## Technical Service Bulletin

GROUP	NUMBER
<b>CAMPAIGN</b>	<b>16-01-049</b>
DATE	MODEL(S)
<b>NOVEMBER 2016</b>	<b>SANTA FE SPORT (AN)</b>

TCU UPDATE – SHIFT QUALITY IMPROVEMENT  
(SERVICE CAMPAIGN TSS)

**TCU ROM ID Table:**

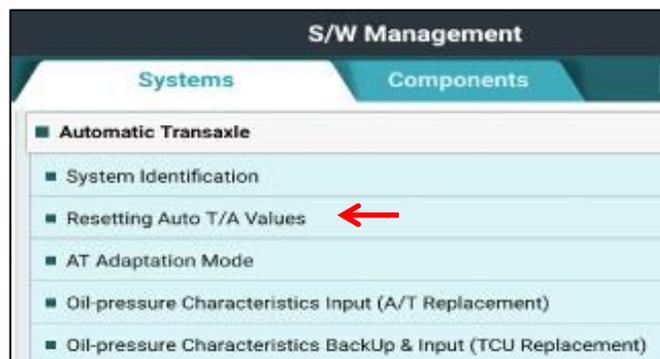
This bulletin provides information related to certain 2017 Santa Fe Sport vehicles to update the TCU for shift quality improvement.

MODEL	ENGINE	TCM P/N	CAL ID	
			OLD	NEW
2017 Santa Fe	2.0L	39100-2GKS0	TAN2T20NS0	TAN2T20NS1
		39100-2GKS5	TAN4T20NS0	TAN4T20NS1
	2.4L	39100-2GKP0	TAN2G24NS0	TAN2G24NS1
		39100-2GKP5	TAN4G24NS0	TAN4G24NS1
		39100-2GKR0	TAN2G24NS0	TAN2G24NS1
		39100-2GKR5	TAN4G24NS0	TAN4G24NS1
